ADDENDUM NO. 3
February 20, 2025

PROJECT: LeRoy Craig Jerome Center
College of Southern Idaho
Jerome, Idaho

Addendum #3 – CSI LeRoy Craig Jerome Center

Date:	02/20/25	To:	LKV Architects
Job Number:	23-319		2400 E. Riverside Drive
Prepared By:	Joe Davies		Boise, ID 83706
Sheet:	1 of 1	Attention:	Greg Bush / Ron Polintan
Project:	<u>CSI – LeRoy Craig Jerome Center</u>

SL2.6

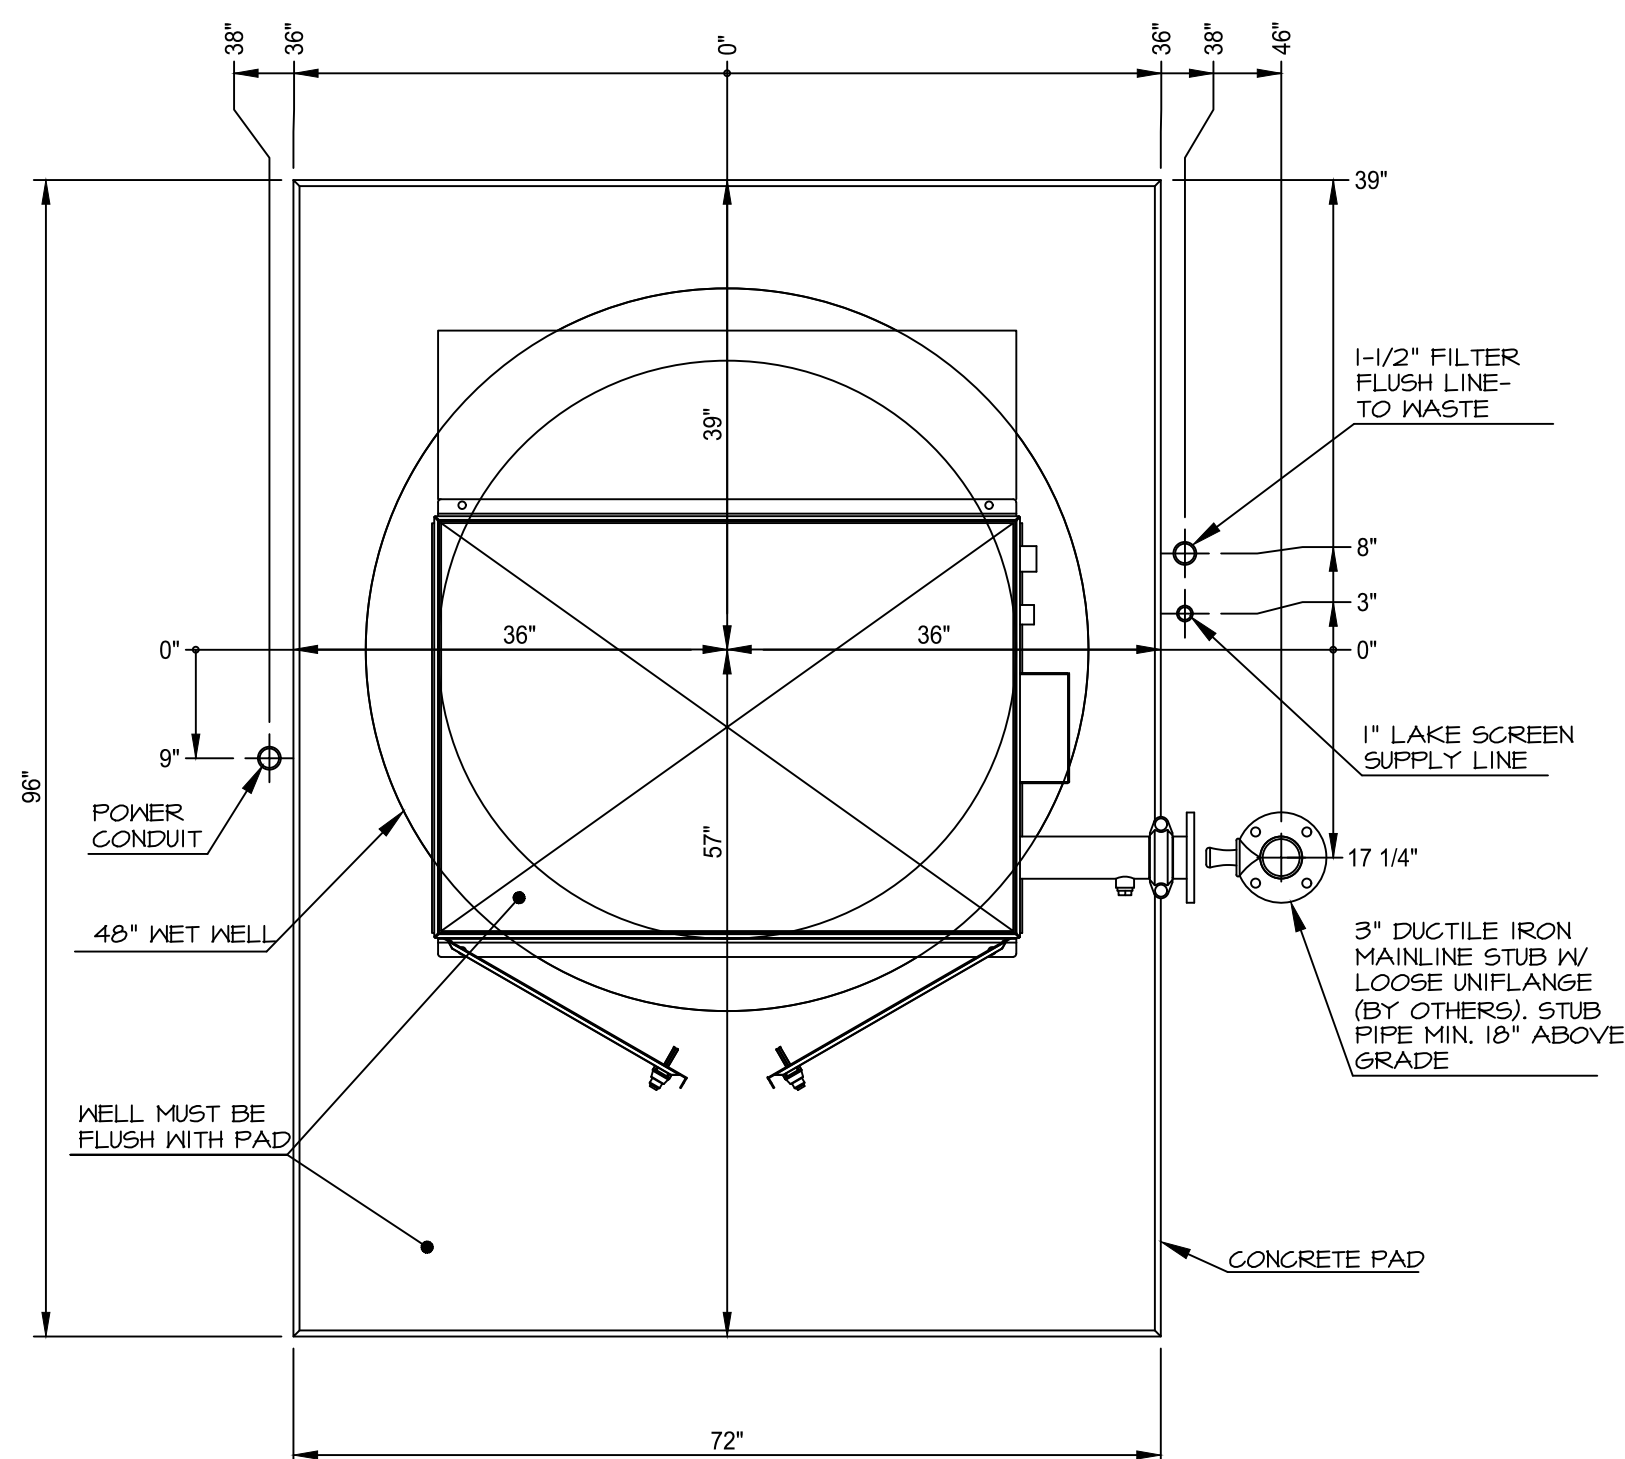
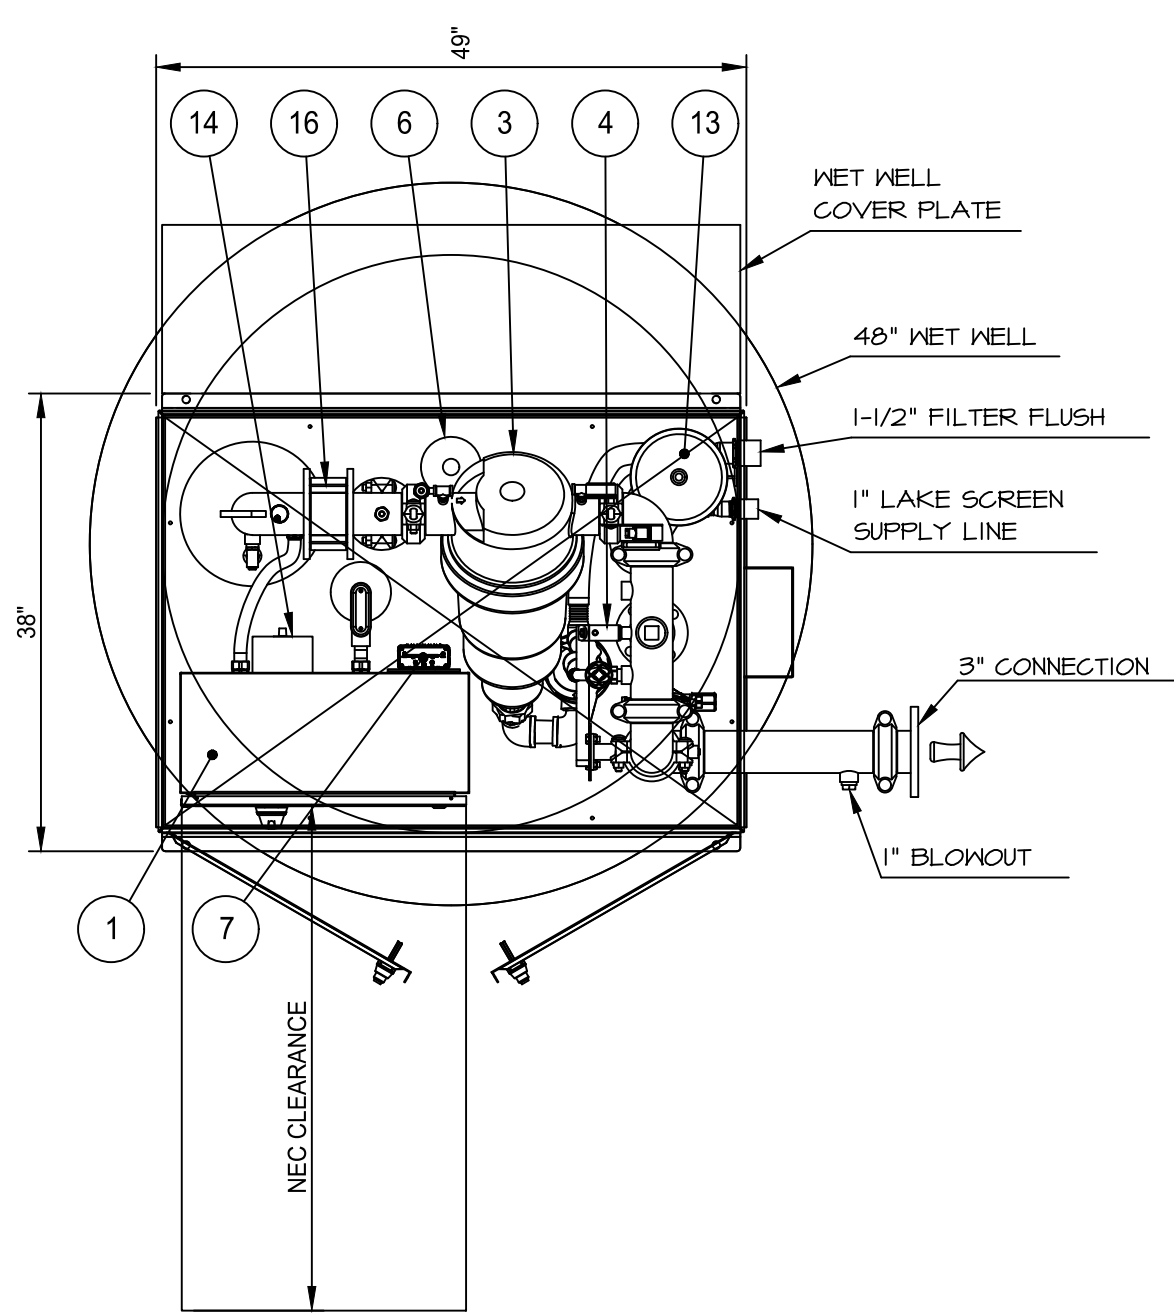
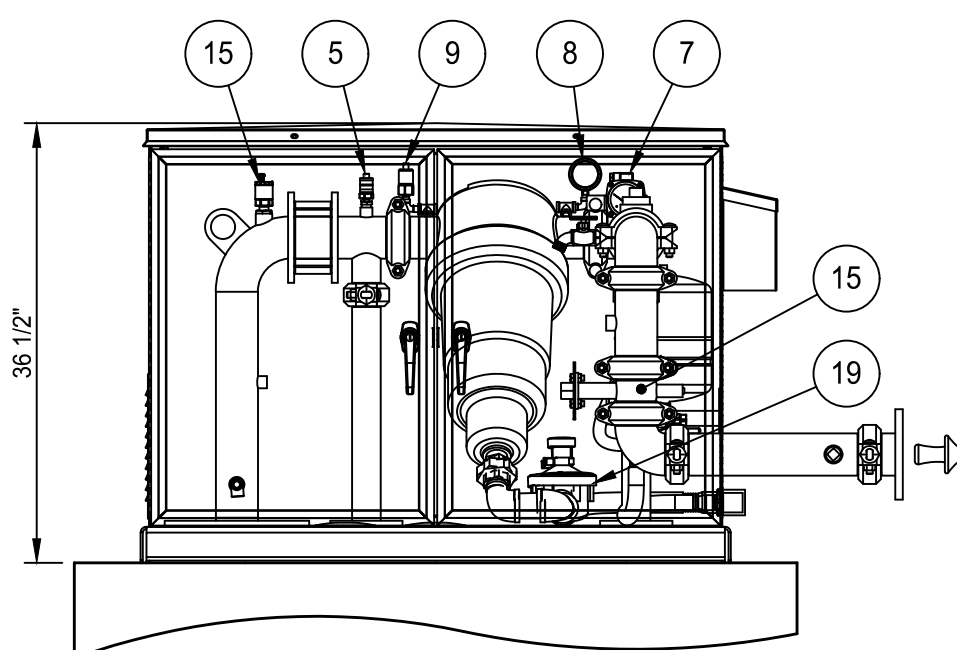
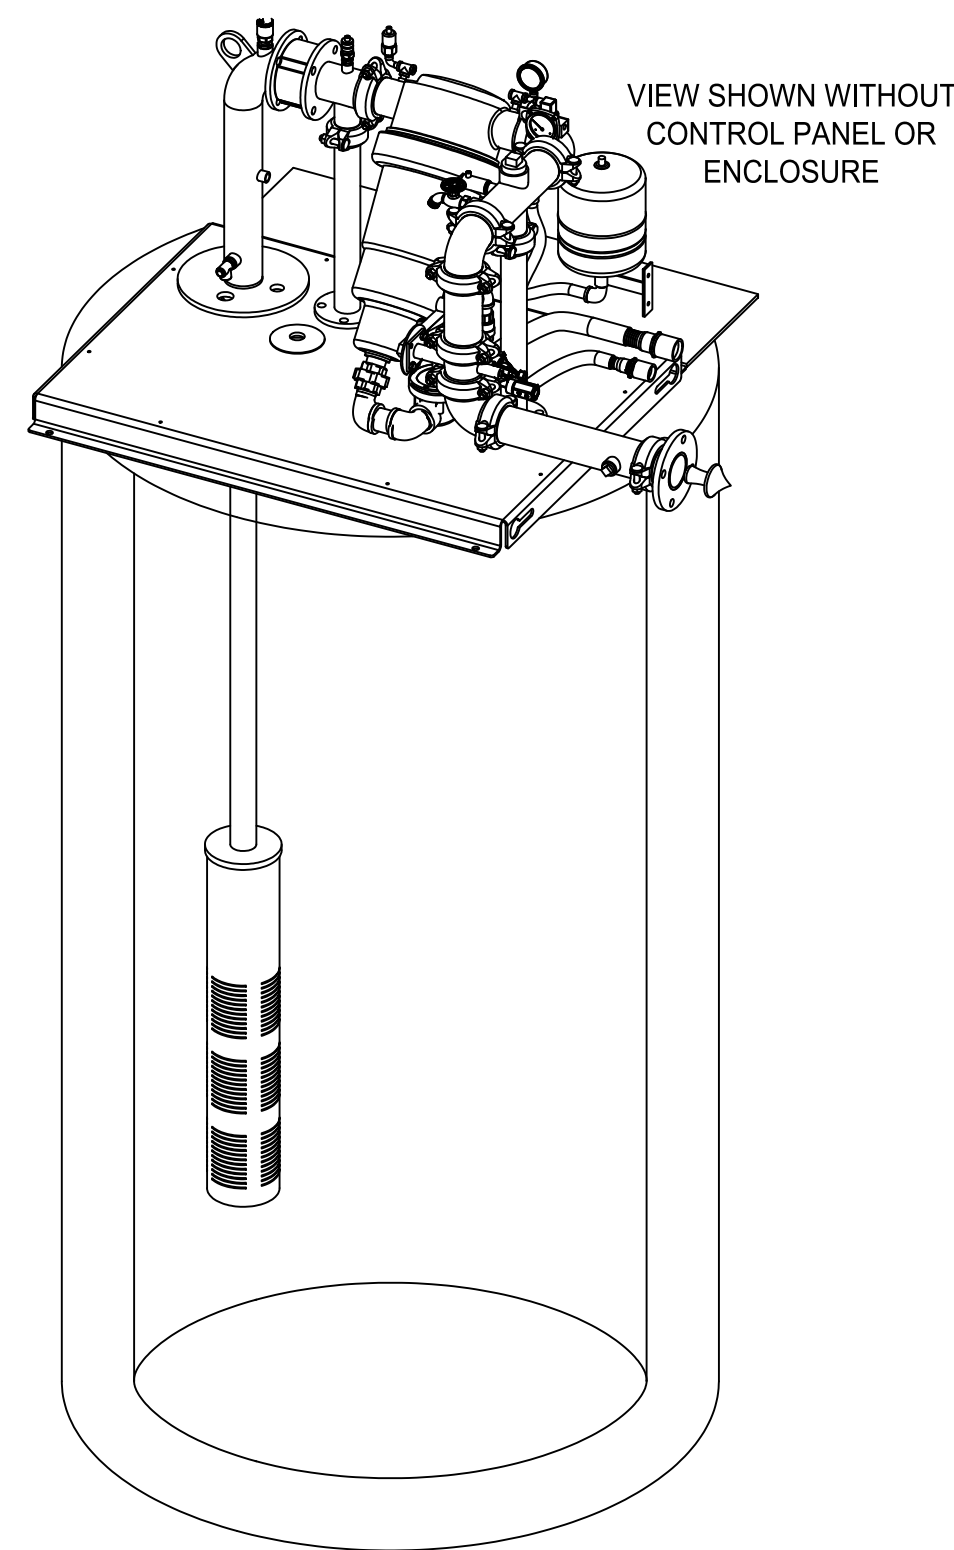
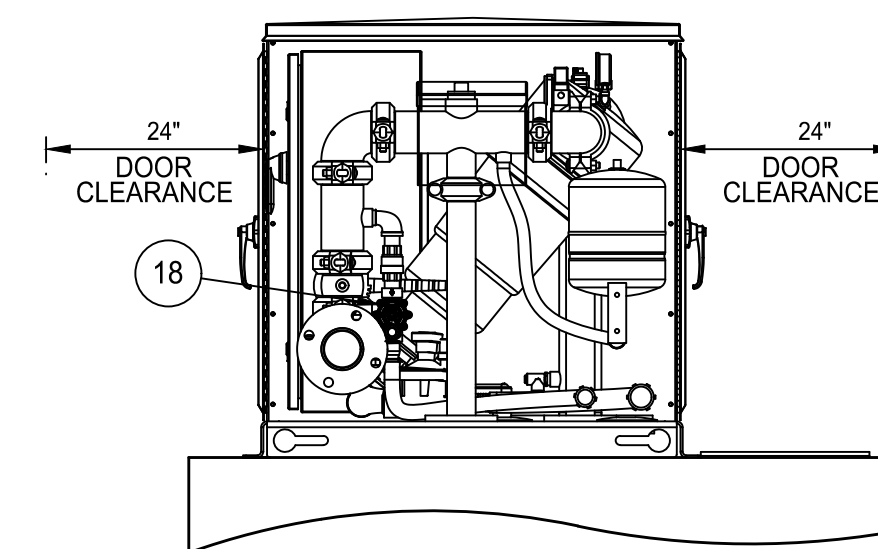
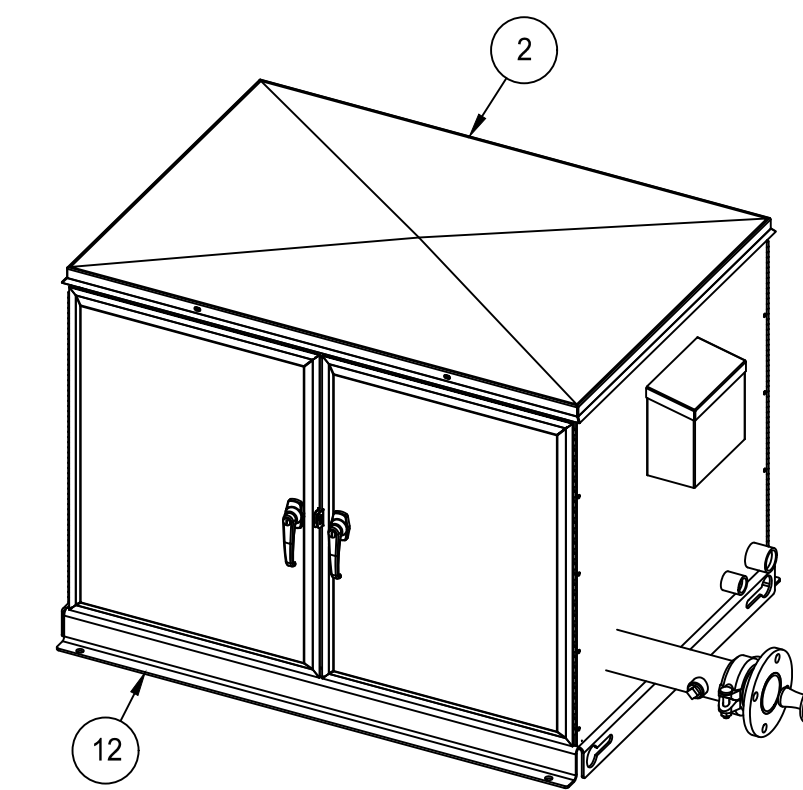
- 1-2 Sheet SD3.0, Add callout 28 for concrete apron at flagpole location.
- 1-3 Sheet SD3.0, Add detail 2 per attached sheet SD3.0A with flagpole concrete apron detail.
- 1-4 Sheet SL2.6, Revise pump station design specifications.

DESIGN SPECIFICATIONS		
DESIGN FLOW RATE:	40 GPM @ 75 PSI	
POWER:	240 VOLT / 1 PHASE	
MODEL #:	5#HV16005X00040-075V32B2410N5-3	
ITEM NO.	DESCRIPTION	QTY
1	CONTROL PANEL	1
2	ENCLOSURE, MARINE GRADE ALUMINUM, 2-DOOR	1
3	FILTER, VAF200	1
4	FLOW METER/FLOW SWITCH	1
5	HIGH PRESSURE SWITCH	1
6	LEVEL SENSOR/FLOAT SWITCH CAP	2
7	MODEM	1
8	PRESSURE DIFFERENTIAL GAUGE & SWITCH	1
9	PRESSURE GAUGE	1
10	PRESSURE TRANSDUCER	1
11	PUMP, SUBMERSIBLE	1
12	SKID, BENT	1
13	TANK, PRESSURE	1
14	UTILITY HEATER	1
15	VALVE, AIR RELIEF, FV-4	1
16	VALVE, BUTTERFLY, GROOVE, LEVER	1
17	VALVE, CHECK, SILENT	1
18	VALVE, FILTER FLUSH	2
19	VALVE, LAKE SCREEN SUPPLY	1
20	VALVE, PRESSURE RELIEF	1
